LEMOORE PLANNING COMMISSION
Regular Meeting
AGENDA
Lemoore Council Chamber
429 'C' Street

To: Lemoore Planning Commission
From: Steve Brandt, City Planner
Date: March 8, 2021
Subject: **Major Site Plan Review No. 2021-02:** a request by Leprino Foods (Kimley-Horn and Associates, agent) to construct a 10-megawatt ground-mounted fixed-tilt photovoltaic solar facility to be located at 351 N. Belle Haven Drive (APN 023-470-006). A common sense Exemption has been prepared in accordance with the California Environmental Quality Act.

DATE: February 9, 2021
SITE PLAN NO: Major Site Plan Review No. 2021-02
PROJECT TITLE: Leprino Foods Solar Project
DESCRIPTION: 33.9acre -10MW Ground Mount Fixed PV Solar Facility
APPLICANT: EnterSolar – Jerry D'Arco
PROPERTY OWNER: Leprino Foods Co. – Brian Demers
LOCATION: 351 N. Belle Haven Drive (West of Hwy 41)
APN(S): 023-470-006

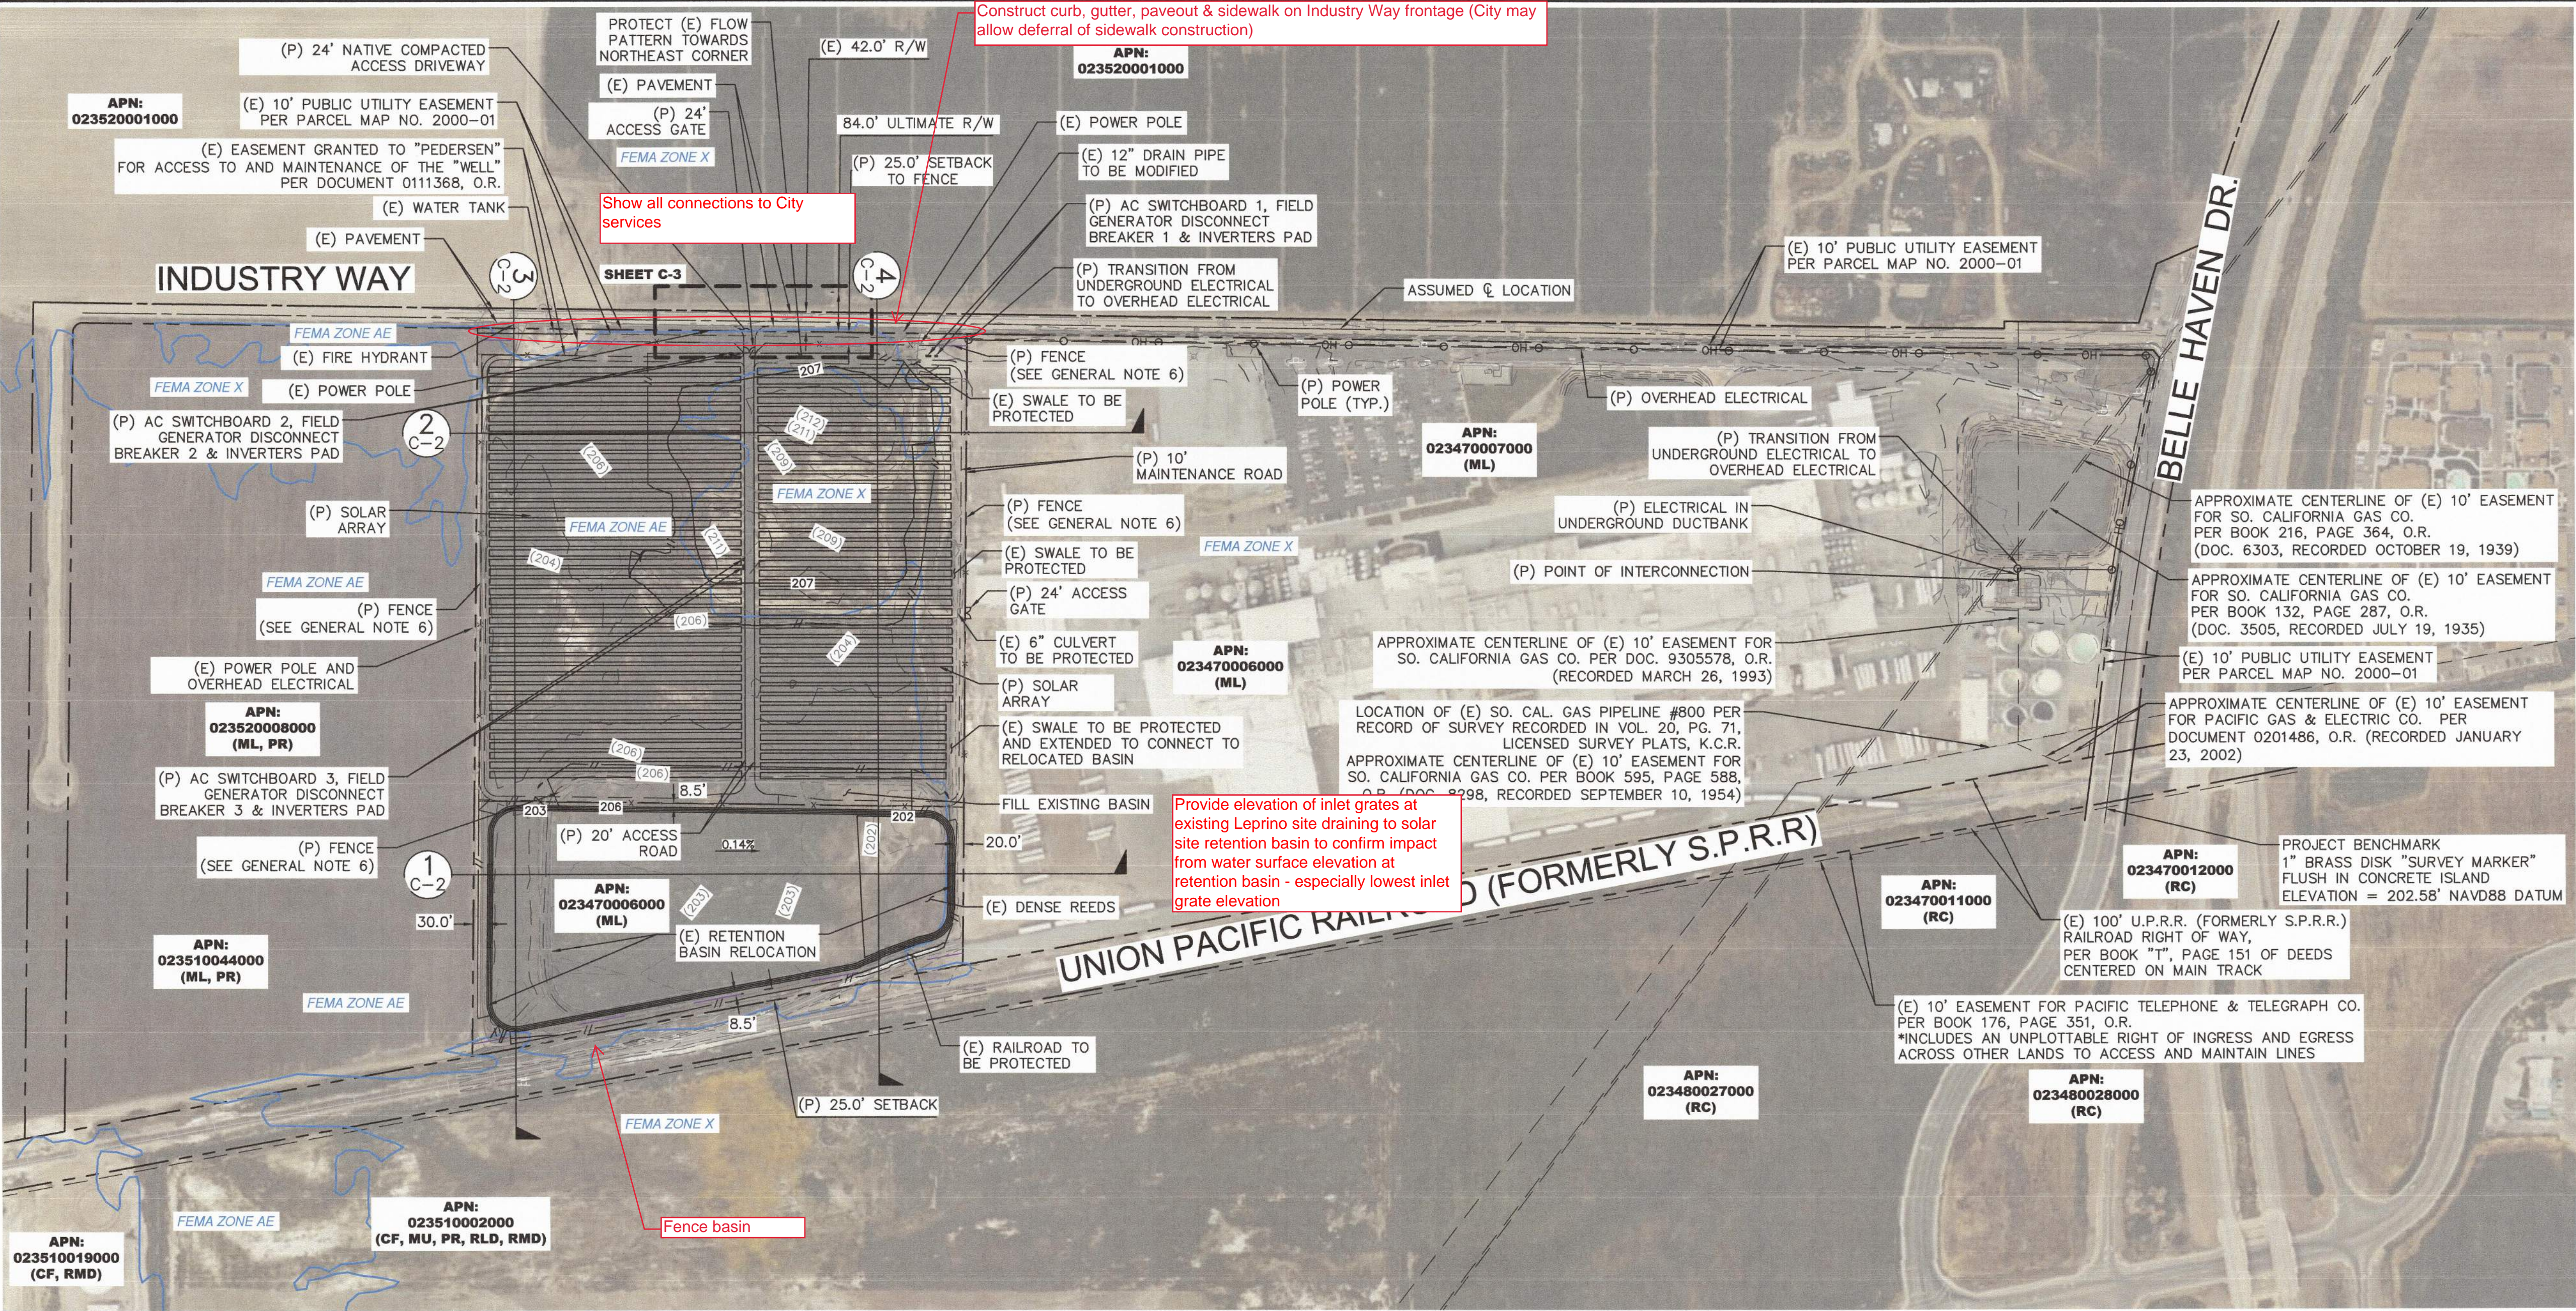
Additional comments: 1) See attached City responses to the Kimley-Horn Memo dated 1/28/21; 2) Project is located in AE flood zone. The electrical service, inverter skid platforms, permanent structures, transformers and similar items are to be a minimum of 1’ above the BFE. The lowest edge of the panels must be at or above the BFE when in full tilt.; 3) Provide covenant or other mutually approved agreement for the joint use of the storm basin. The covenant or document shall be recorded with the County Recorder prior to approval of the permit.

City of Lemoore
Public Works/City Engineering
Site Plan Review Comments

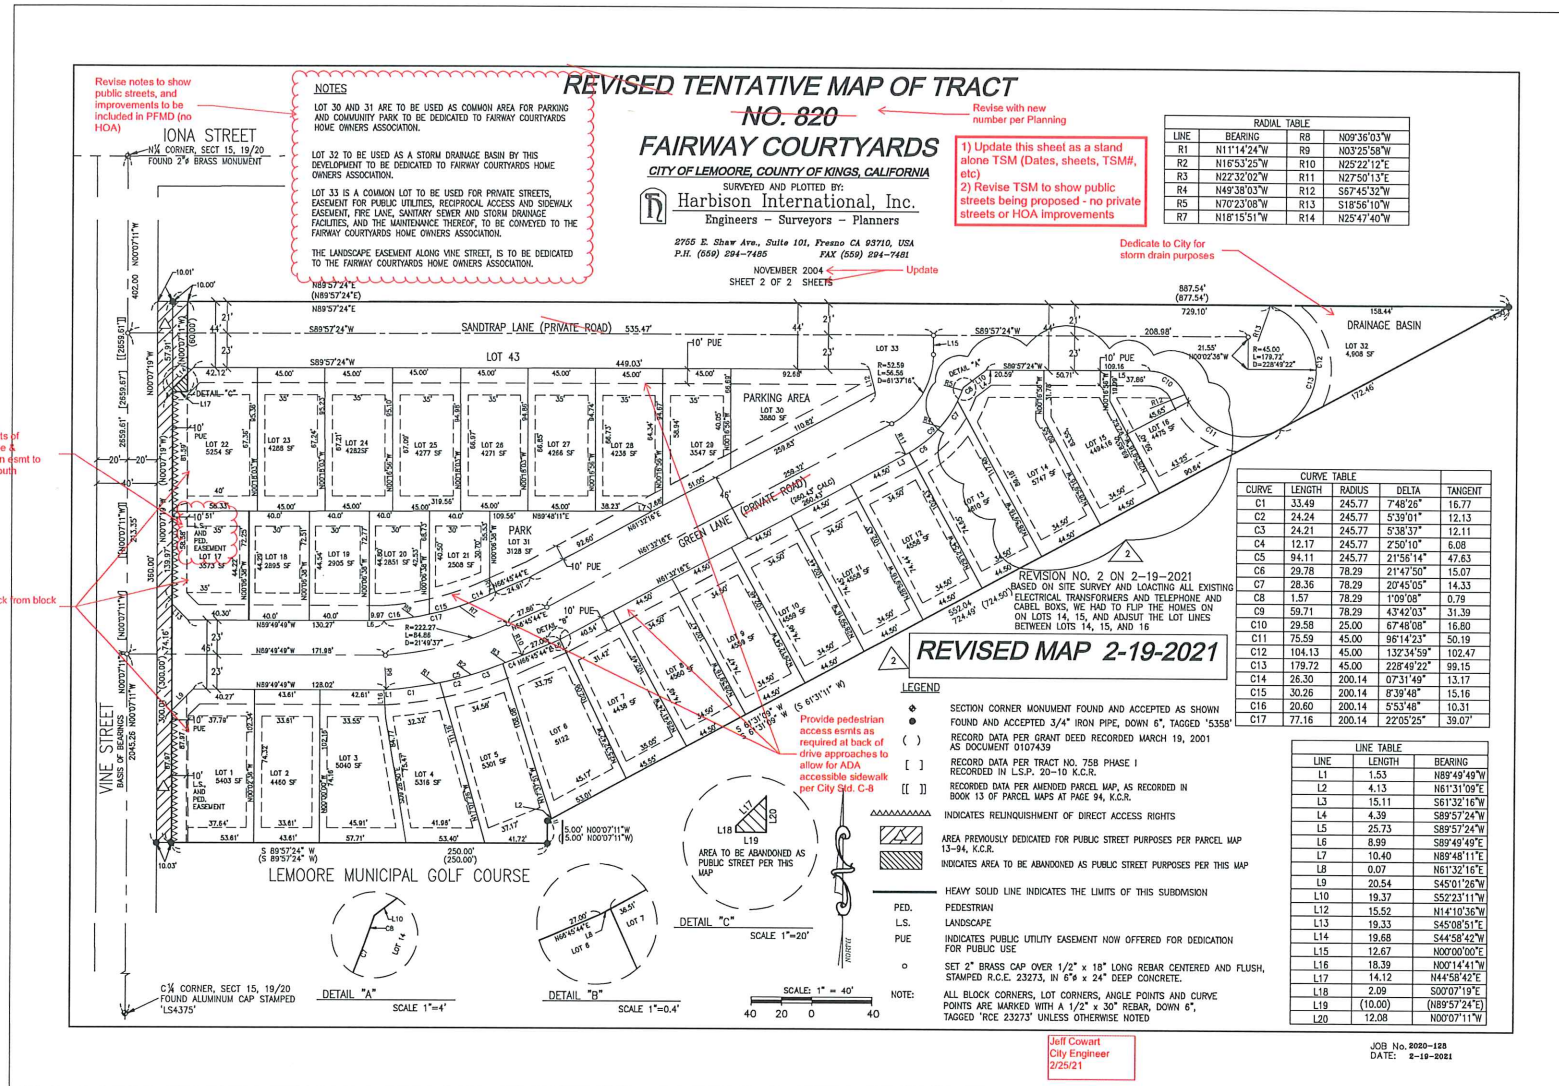
17. Show existing sanitary sewer, storm drainage, water and street infrastructure associated with development.
18. Lowest grade elevation within development shall be 1 foot above high-water level in ponding basin.

19. Fire hydrants to be spaced at a maximum distance of 300 feet.
20. Provide streetlights along the east side of Vine Street and within development.
21. A digital copy of the improvement plans and final map shall be provided to the City upon final approval.

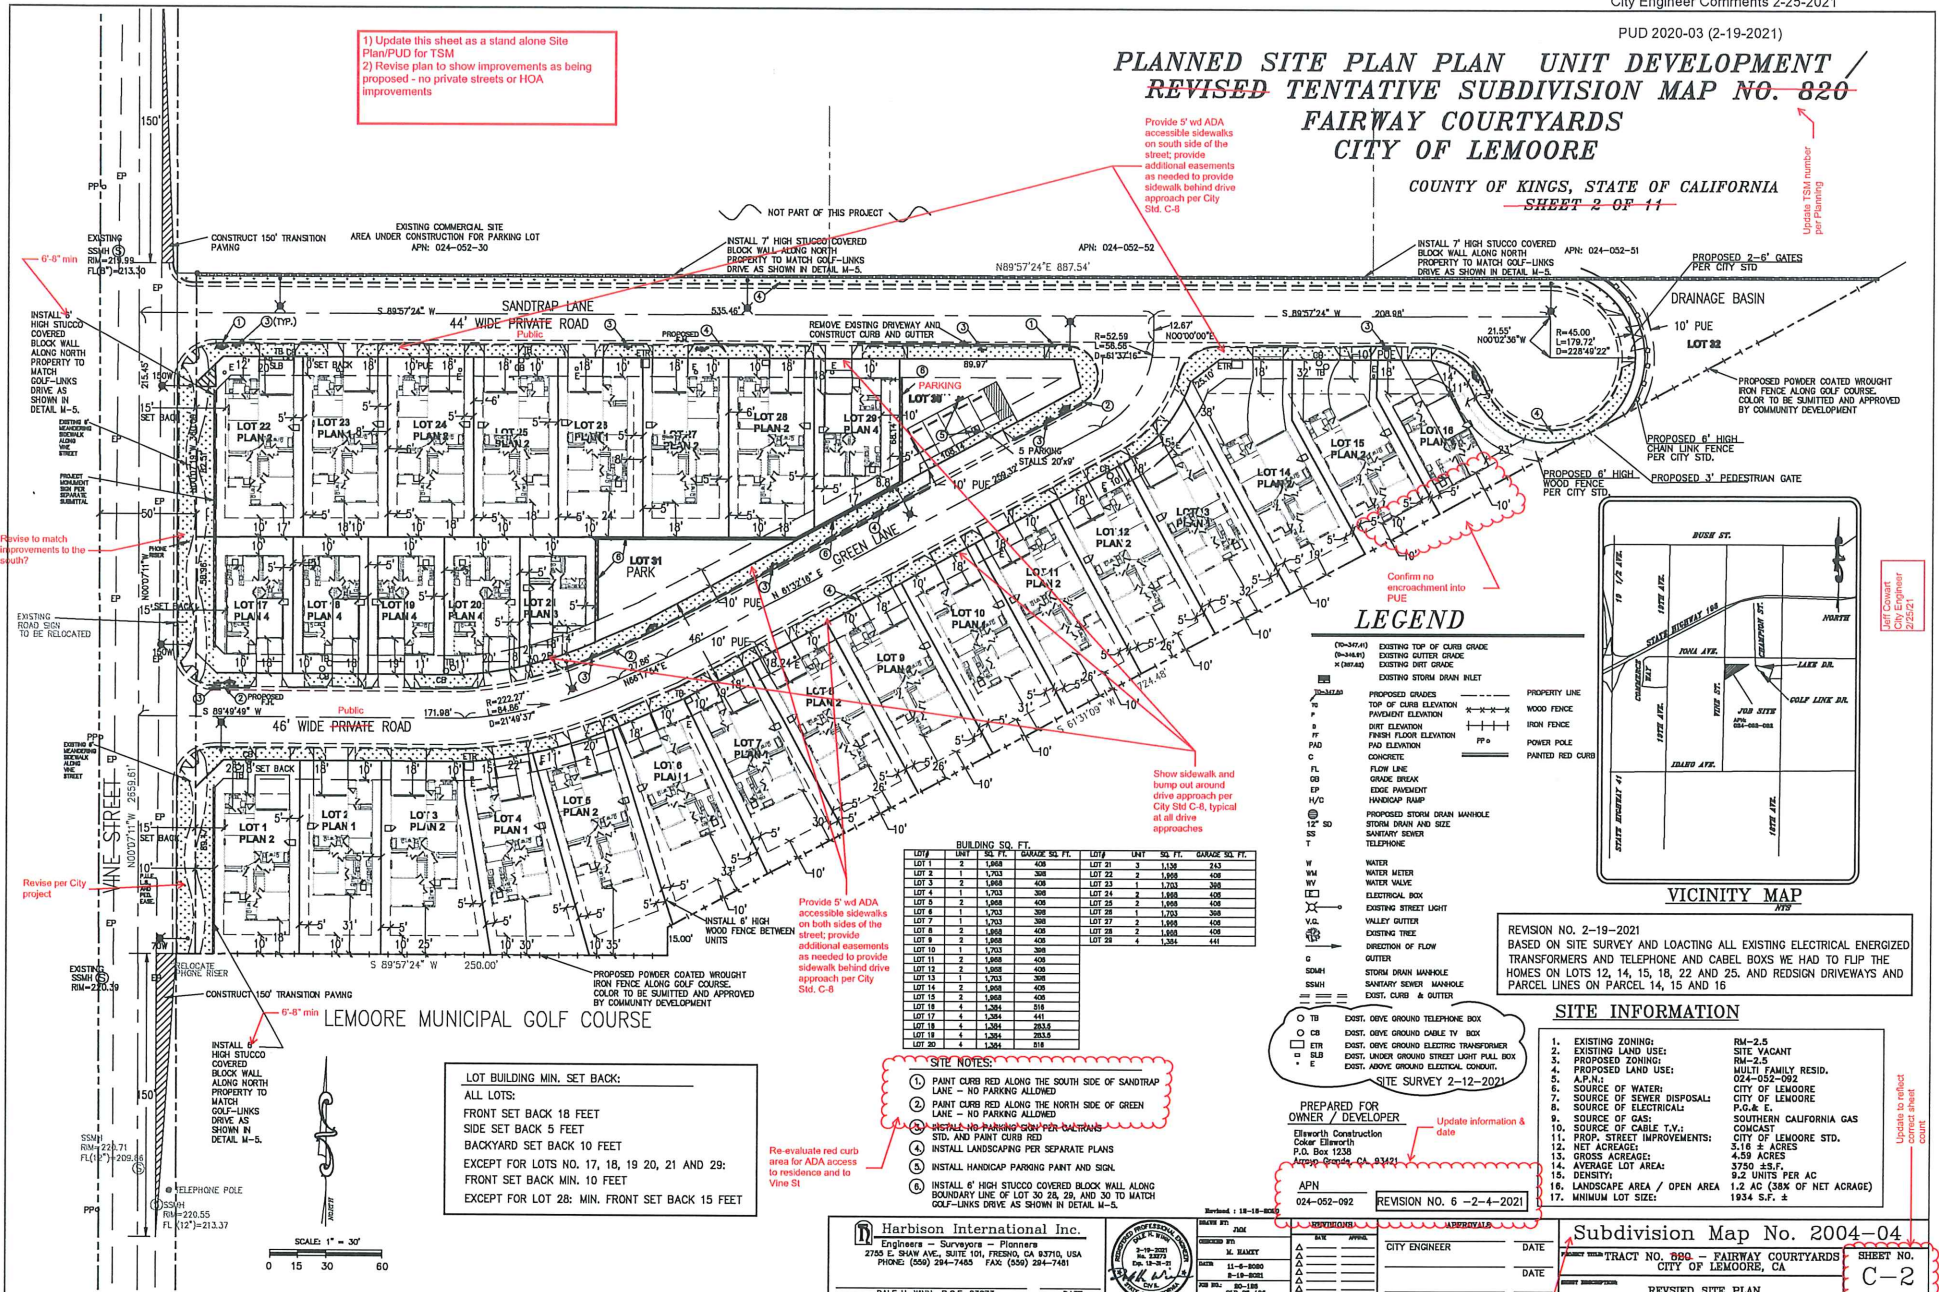
Provide 5' wd ADA accessible sidewalks on south side of the street; provide additional easements as needed to provide sidewalk behind drive approach per City Std. C-8

Update TSM number
Super Planning

correct sheet
count
